North Carolina Department of Transportation  
**PROJECT ENVIRONMENTAL CONSULTATION FORM**  
**TIP No. U-3615B**

- a. Consultation Phase: Construction
- b. Project Description SR 1820 (Skeet Club Road) –  
West of SR 1818 (Johnson Street) to NC 68  
(Eastchester Drive)  
In Guilford County
- c. WBS: 34962.1.1  
State Project: 8.2494701  
Federal Project: STP-1820(2)
- d. Document Type: EA December 23, 2002  
FONSI May 24, 2004  
Right of Way Consultation February 17, 2009

## DESIGN CHANGES

**DETAIL 9**  
(Not to Scale)

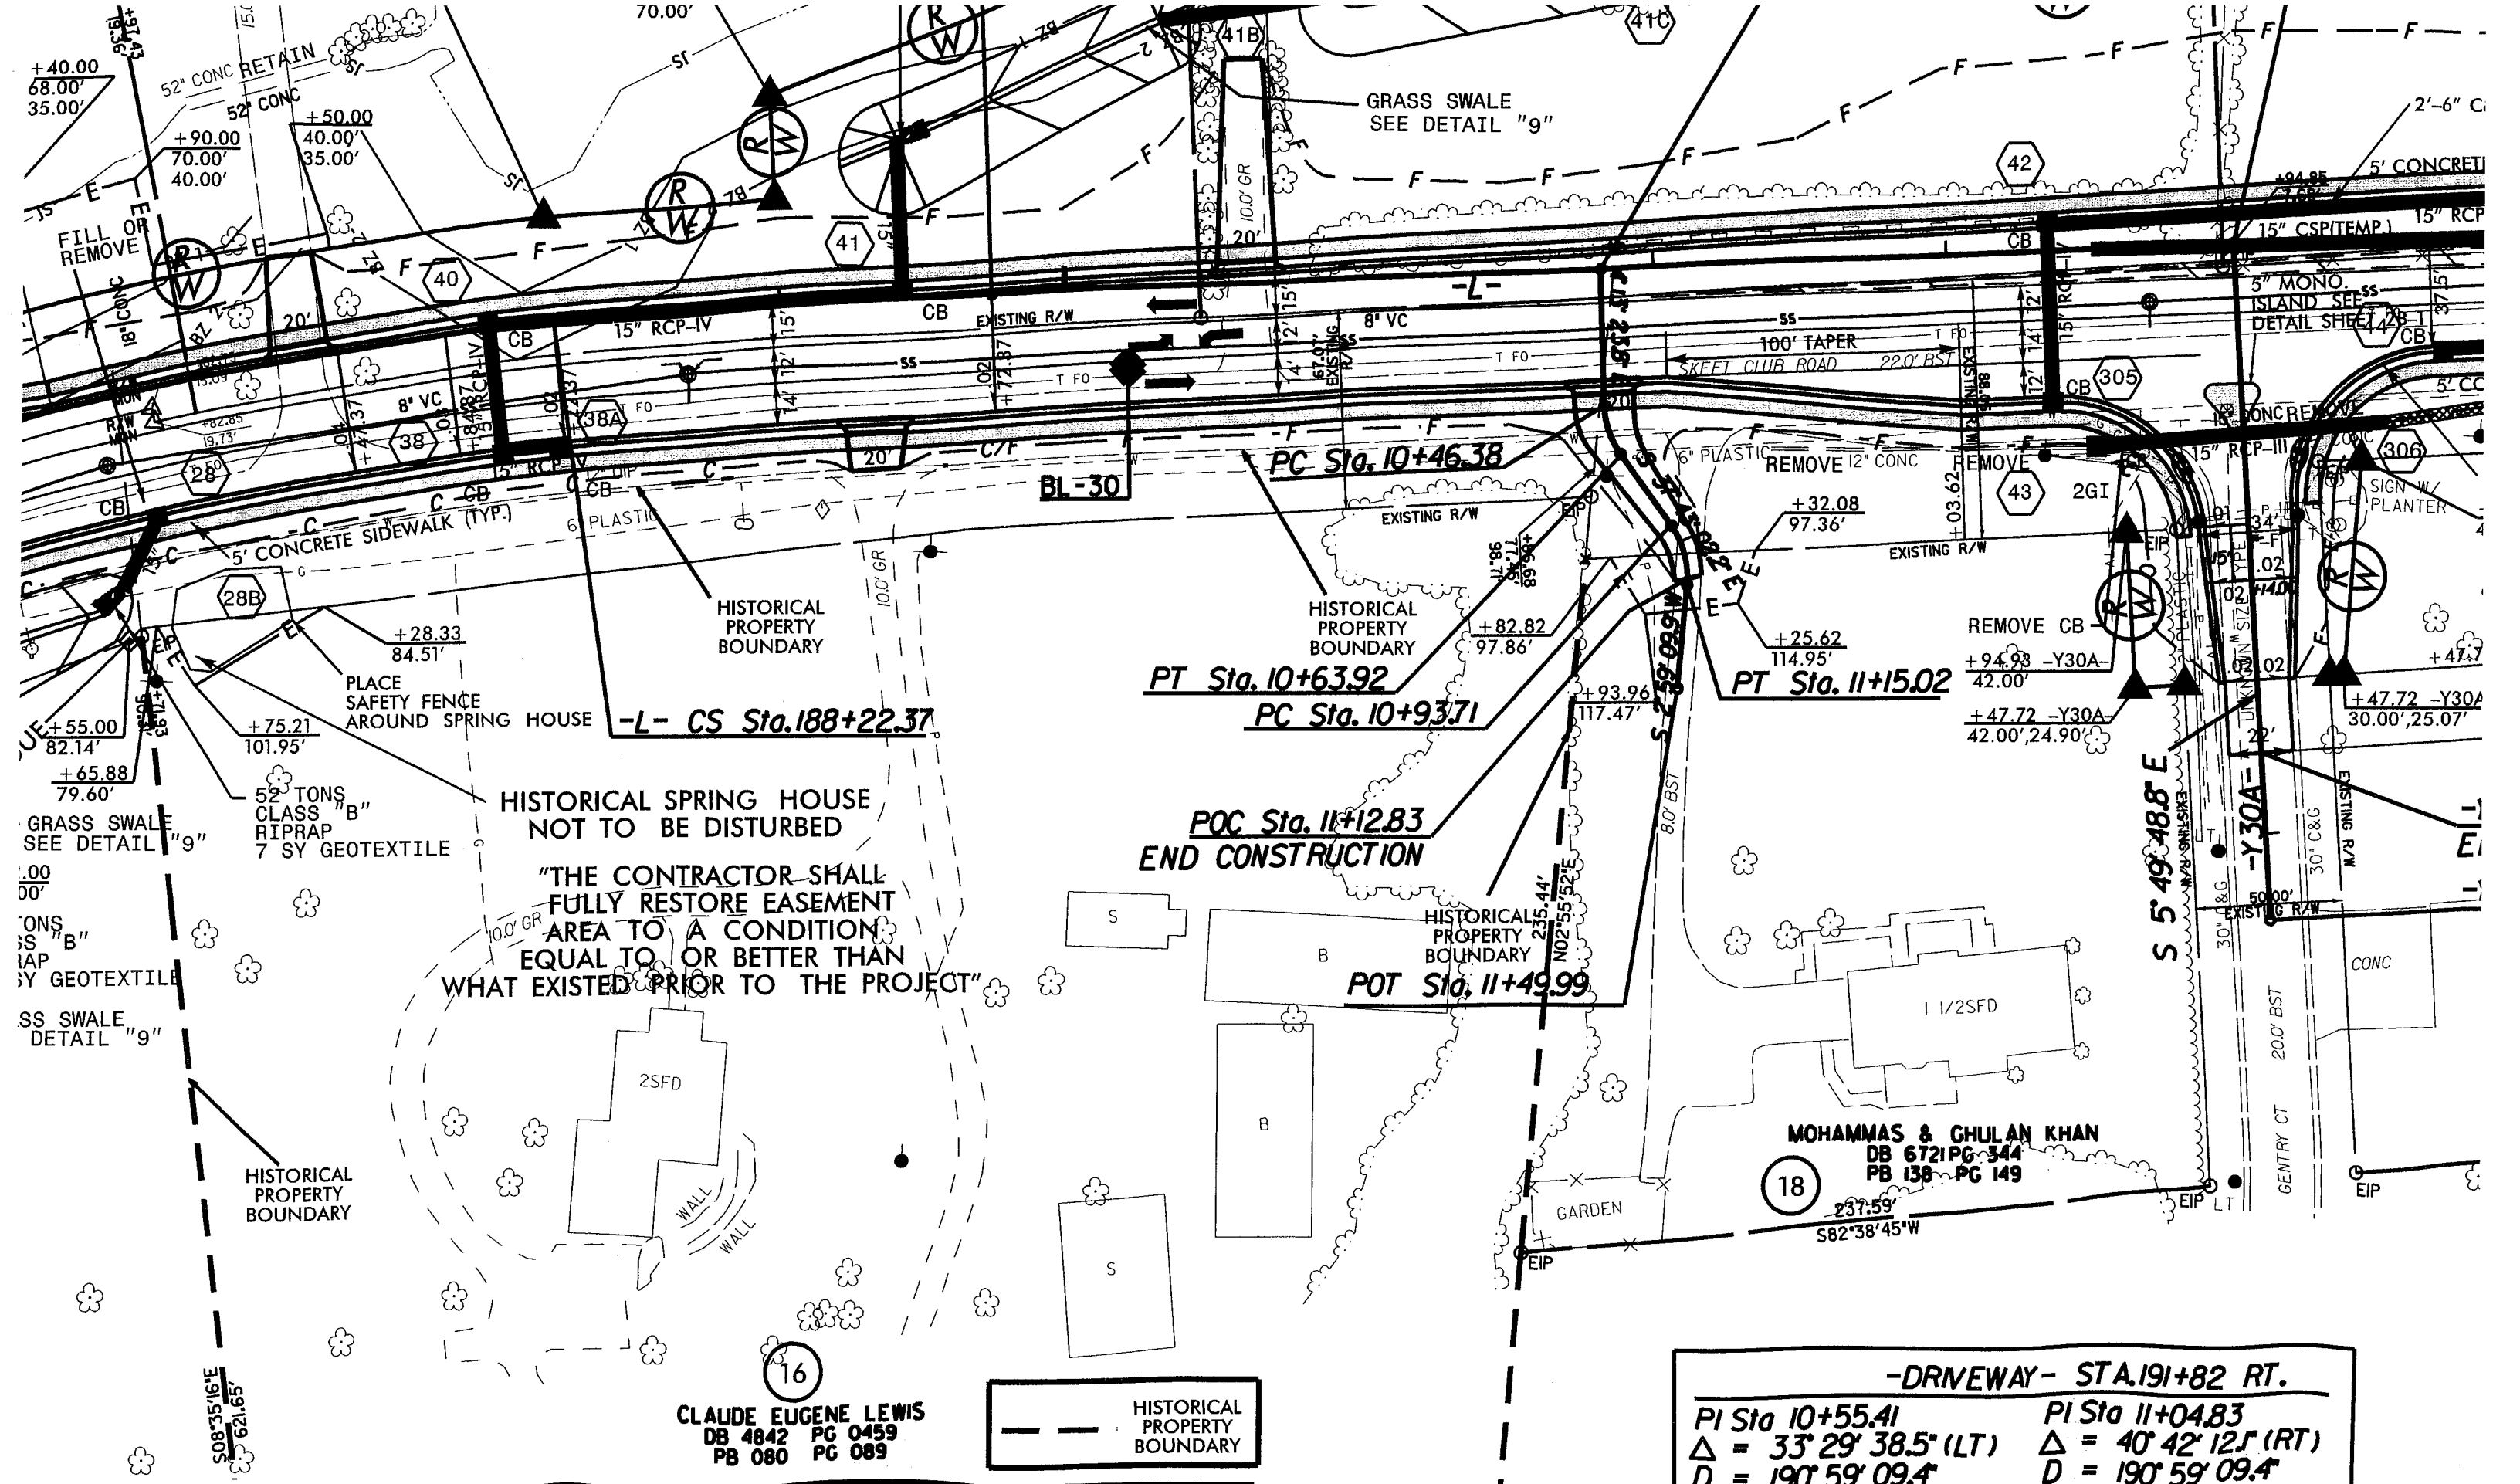
2. Removed the fill slope off the Spring House Ruins, Sta. 186+60± –L– to 187+30± –L–, without a retaining wall and added the following safeguards for the historic resource:

- Addition of a Temporary Construction Easement for the protection of the Spring House Ruins;
- Safety Fence be placed around the Spring House Ruin, and;
- A note stating “Historical Spring House Not To Be Disturbed”

The plans were presented to SHPO, November 13, 2014, it was determined that the Safety Fence though temporary would result in "no adverse effect" on the historic property, see the attached concurrence form, dated November 19, 2014.
